# Access Compliance Report

## Public Rights-of-Way

Intersection ID: 42944	Main Street: TURNING_WHEEL_DR	Cross Street: SONOMA_VALLEY_DR	Location: SW
ADA ID: E4F14B91B168	Ramp Type: PerpDiag	Initial Pass/Fail: Fail	Overall Compliance: No
		Severity Score: 8.75

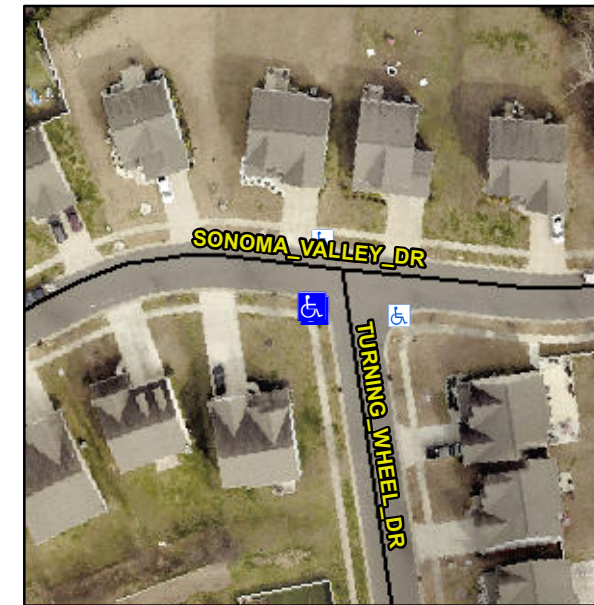
**Not Found, R304.5.1**

Compliance	Description	Data	Compliance	Description	Data
N/A	Ramp Length (in)	72.5	Yes	Ramp Slope (%)	7.1
No	Ramp Width (in)	47.0	Yes	Ramp XSlope (%)	1.0
N/A	Flare Type LT	N/A	N/A	Flare Type RT	N/A
N/A	Flare Slope LT (%)	N/A	N/A	Flare Slope RT (%)	N/A
N/A	Flare Traversable LT?	N/A	N/A	Flare Traversable RT?	N/A
N/A	Landing Length (in)	N/A	N/A	DWS Provided?	N/A
N/A	Landing Width (in)	N/A	N/A	DWS Contrast?	N/A
N/A	Landing Slope (%)	N/A	N/A	DWS Length (in)	N/A
N/A	Landing X Slope (%)	N/A	N/A	DWS Full Width?	N/A
N/A	Landing Curb? (Y/N)	N/A	N/A	DWS Offset (in)	N/A
N/A	Shared Landing?	N/A			
N/A	Gutter Ponding?	N/A	N/A	Gutter Slope (%)	N/A
N/A	Gutter Lip Ht (in)	N/A	N/A	Gutter X Slope (%)	N/A
N/A	Painted X Walk1?	No	N/A	Painted X Walk2?	No
	X Walk 1 Direction	To E		X Walk 2 Direction	To N
N/A	X Walk 1 Width (in)	N/A	N/A	X Walk 2 Width (in)	N/A
	X Walk 1 Slope (%)	2.9		X Walk 2 Slope (%)	3.5
	X Walk 1 X Slope (%)	1.7		X Walk 2 X Slope (%)	4.4

**Remove & Replace Curb Ramp With Two New Directional Ramps or Equivalent.**
